SECTION 00 9111
ADDENDUM NUMBER 01

DATE: August 19, 2024

PROJECT: S-29 Miller Armory Latrine Addition

PROJECT NUMBER: 2112209640

B3 LEVEL 1 DOMESTIC WATER PLAN
 1/4" = 1'-0" 0' 6"

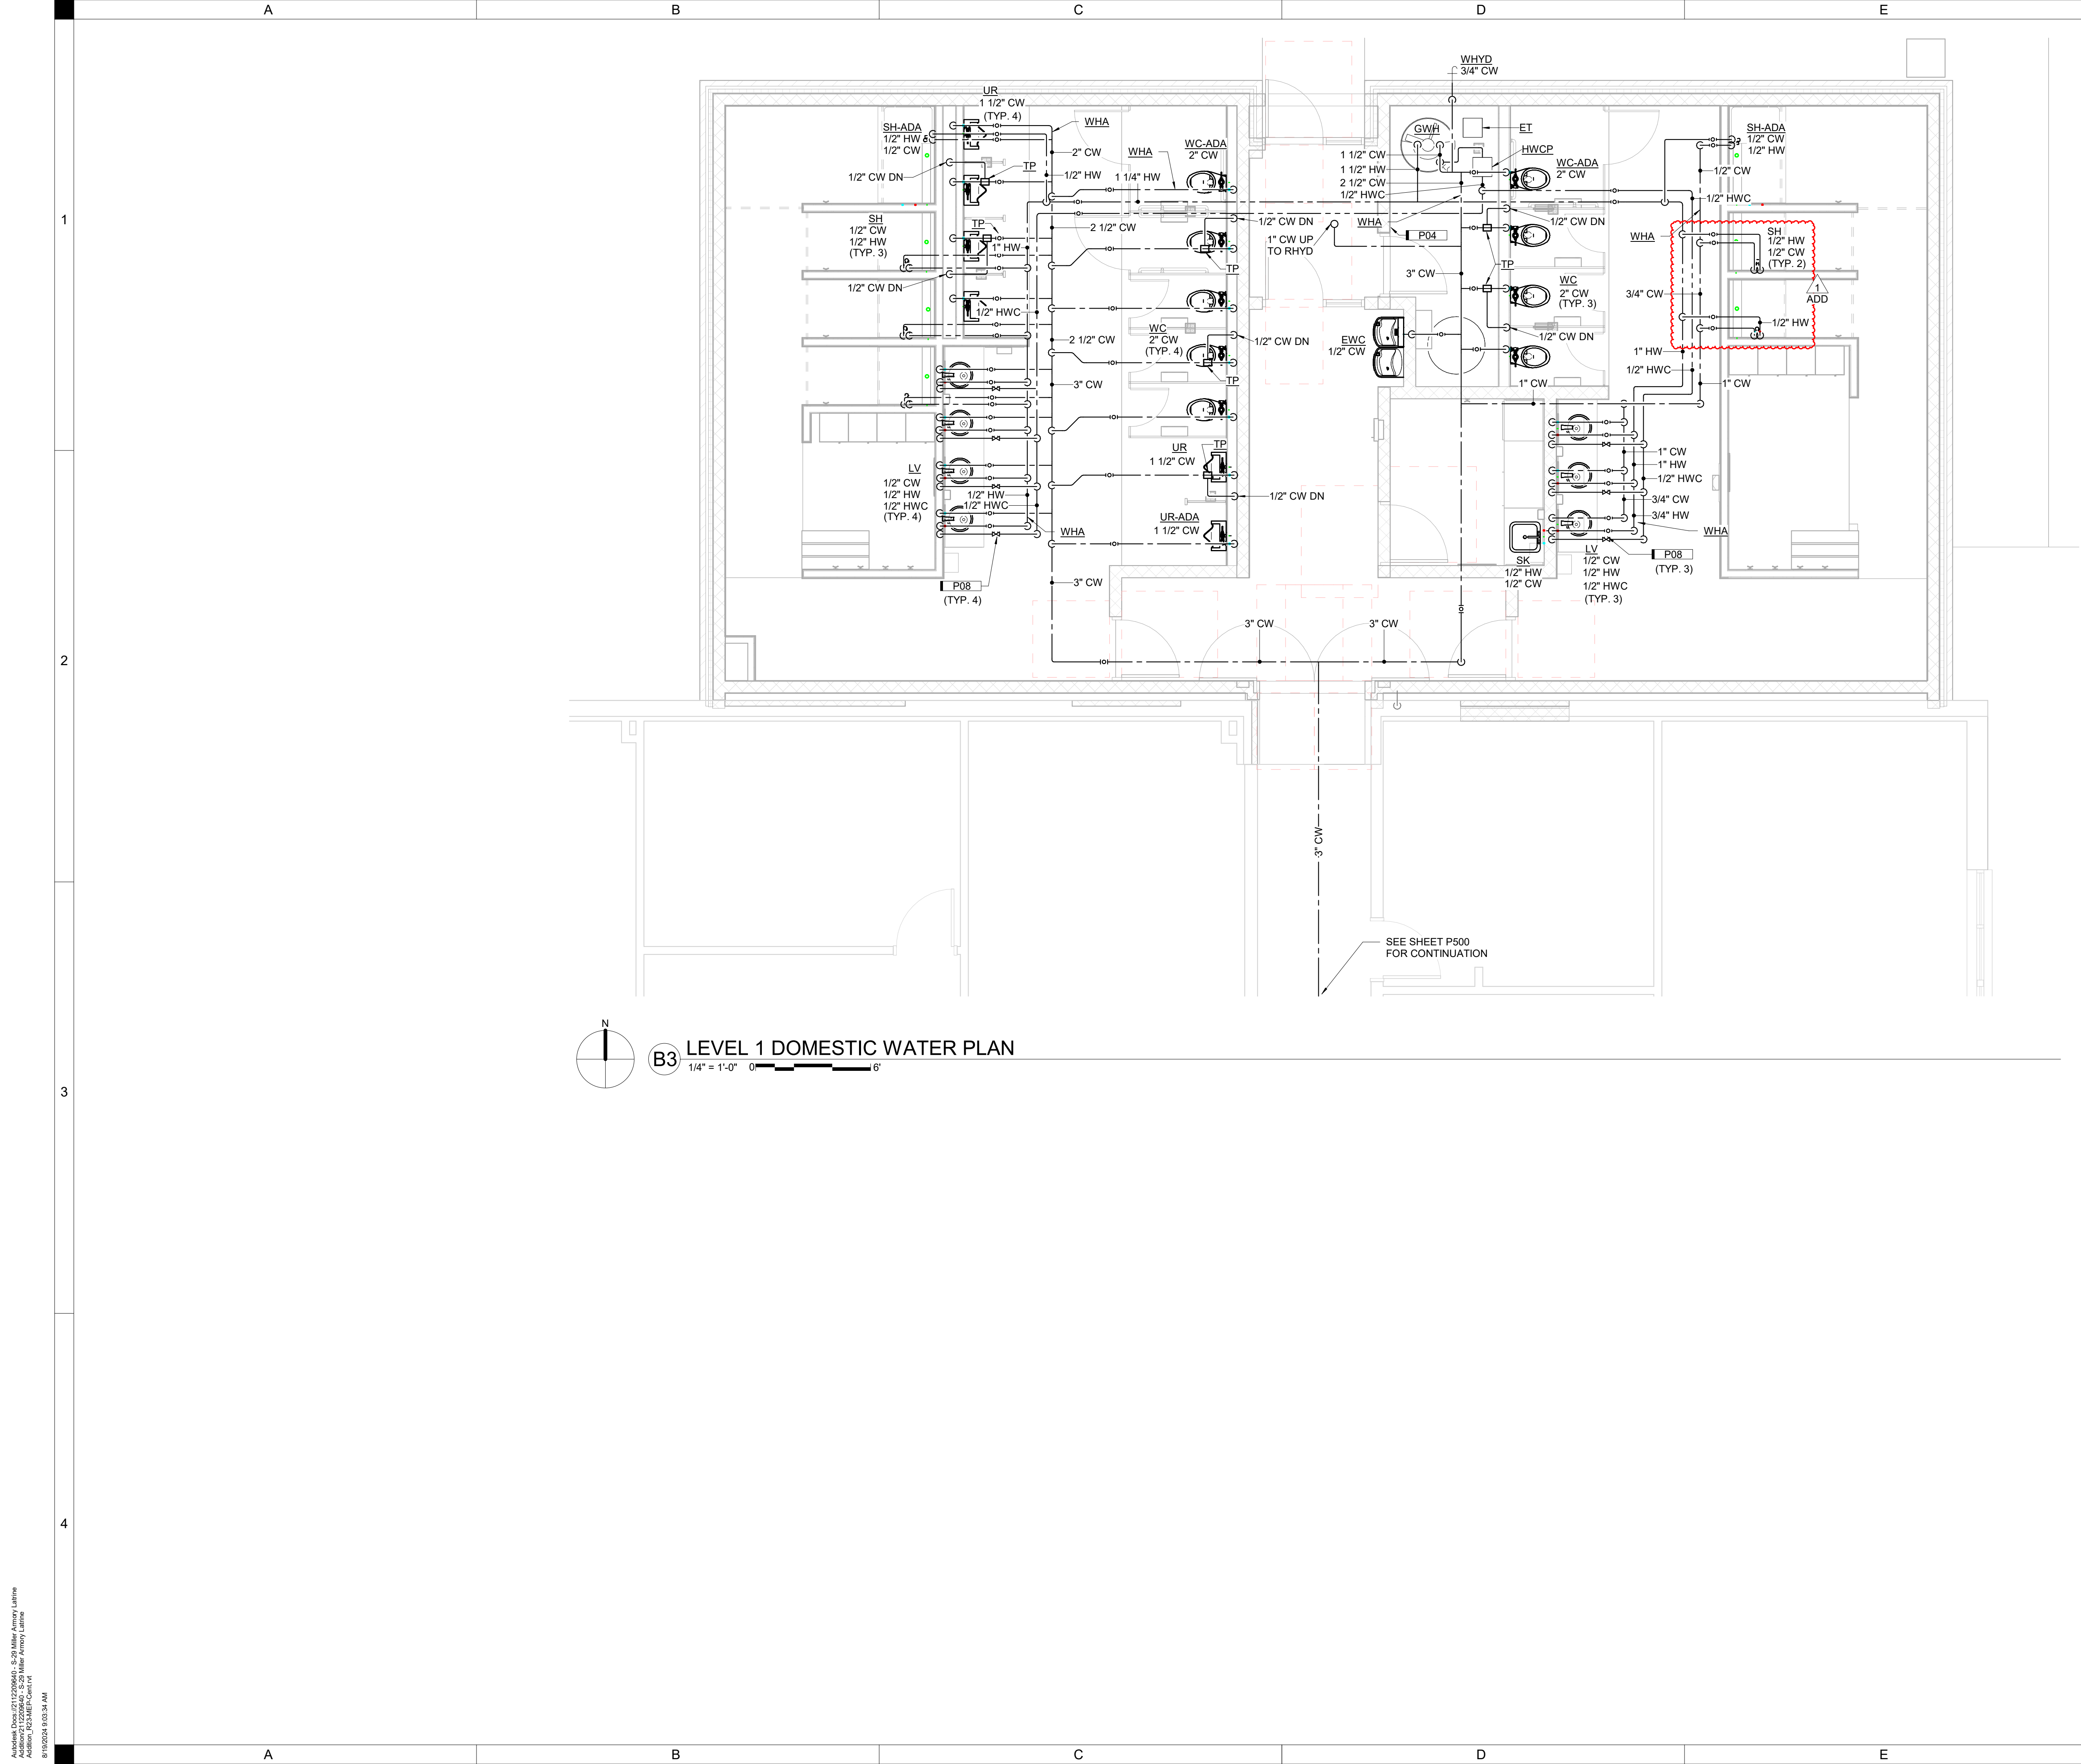
1. **REVISE** the domestic water piping to the showers in the women’s shower area.
